Access Compliance Report

Public Rights-of-Way

(Curb Ramps)

Intersection ID: 2718	Main Street: SKYLINE_DR	Cross Street: HIGHLAND_CREEK_PY	Location: SE
ADA ID: 0A2C2FA76D62	Ramp Type: Perp	Initial Pass/Fail: Fail	Overall Compliance: No
		Severity Score: 8.75

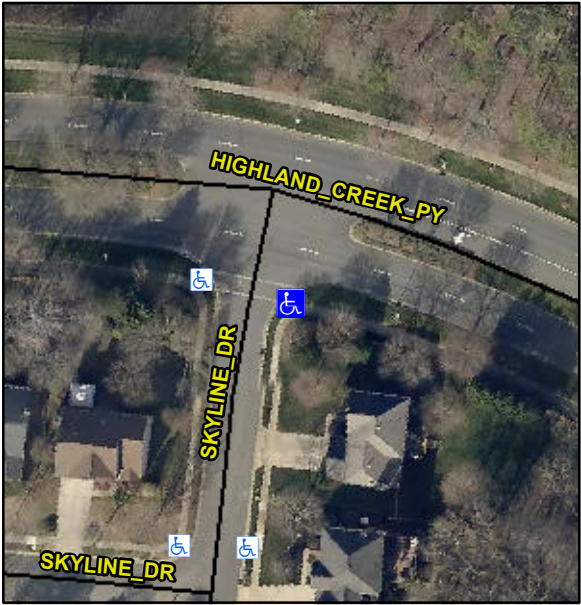
Codes/Mitigation Info/Possible Solution			Field Measurements/Component Compliance		
	Possible Solutions:		Compliance	Description	Data
	Remove & Replace Entire Ramp.		N/A	Ramp Length (in)	74.0
			No	Ramp Width (in)	41.0
			N/A	Flare Type LT	N/A
			N/A	Flare Slope LT (%)	N/A
			N/A	Flare Traversable LT?	N/A
			N/A	Landing Length (in)	N/A
			N/A	Landing Width (in)	N/A
			N/A	Landing Slope (%)	N/A
			N/A	Landing X Slope (%)	N/A
<p>Surveyor Notes:</p> <p>N/A</p> <p>PROW/ADA:</p> <p>R304.5.1</p>			N/A	Flare Type RT	N/A
			N/A	Flare Slope RT (%)	N/A
			N/A	Flare Traversable RT?	N/A
			N/A	DWS Provided?	N/A
			N/A	DWS Contrast?	N/A
			N/A	DWS Length (in)	N/A
			N/A	DWS Full Width?	N/A
			N/A	DWS Offset (in)	N/A
			N/A	Shared Landing?	N/A
			N/A	Gutter Ponding?	N/A
			N/A	Gutter Lip Ht (in)	N/A
			N/A	Painted X Walk1?	Yes
				X Walk 1 Direction	To NW
			N/A	X Walk 1 Width (in)	96.0
				X Walk 1 Slope (%)	3.6
				X Walk 1 X Slope (%)	0.6
